DEVELOPMENT REVIEW COMMITTEE (DRC) COMMENT REPORT

PROJECT NAME: Victoria Park Townhomes

CASE NUMBER: R18040

REQUEST: Site Plan Level II Review:
6 Residential Townhouse Units

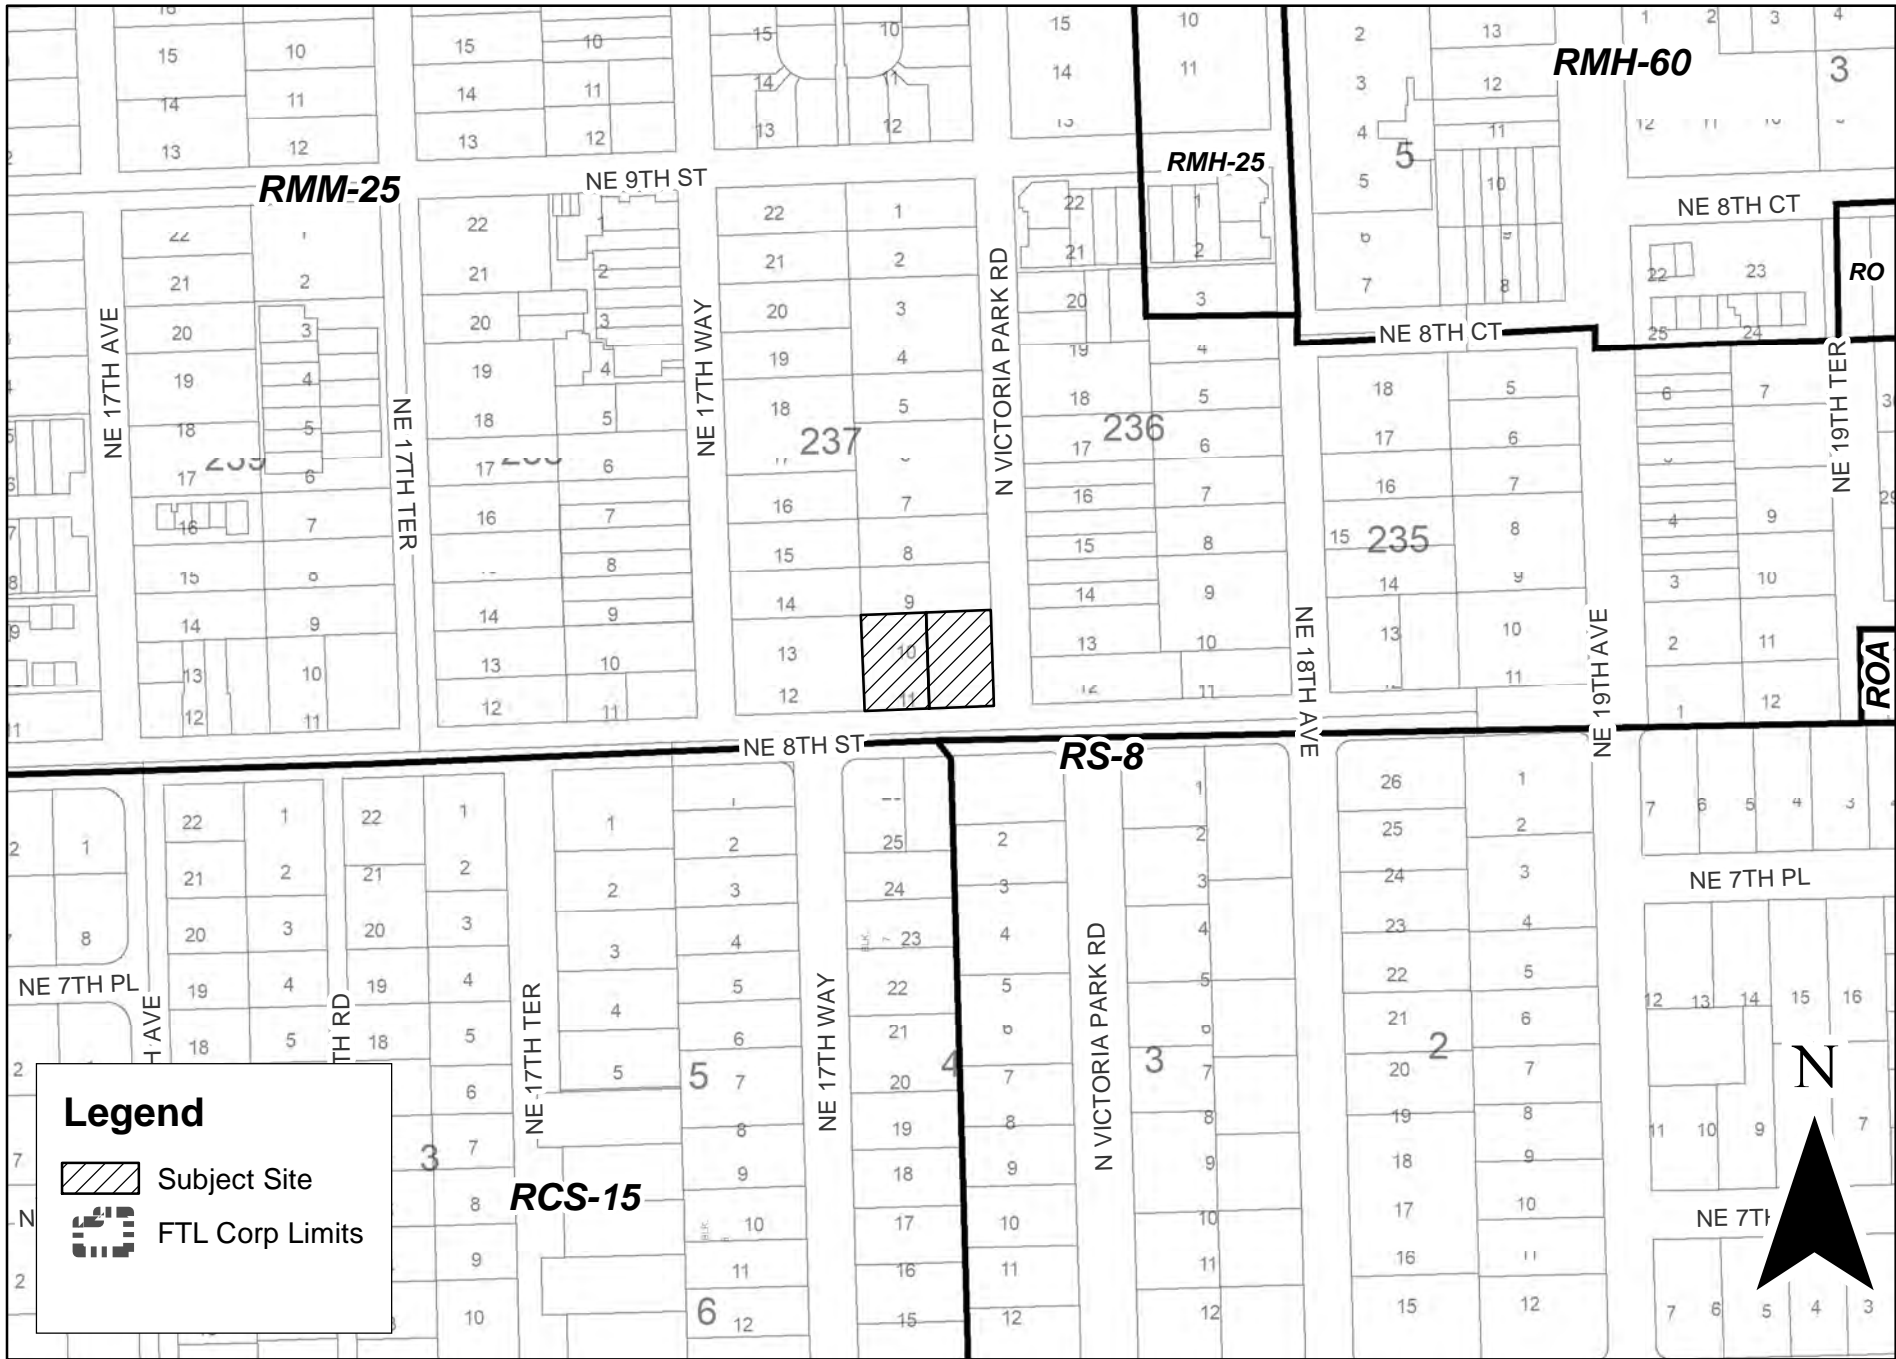
- 14) Provide legible photometric plan for the entire site. Extend values on photometric plans to all property lines. Show values pursuant to the Unified and Land Development Regulations ("ULDR"), Section 47-25.3.A.3.a and 47-20.14. Indicate lighting poles on site plan and landscape plan, and provide detail with dimensions. Garage internal lighting fixtures and glare cannot be visible from neighboring properties.

Indicate lighting poles on site plan and landscape plan, and provide detail with dimensions. Light poles appear within the parking stalls, please clarify on plans. Consider reduced height of poles due to proximity of the project nearby residential area. Be aware that if lighting fixtures greater than ten (10) feet in height are used, they shall be located a minimum of fifteen (15) feet away from shade trees (Sec. 47-20.14)
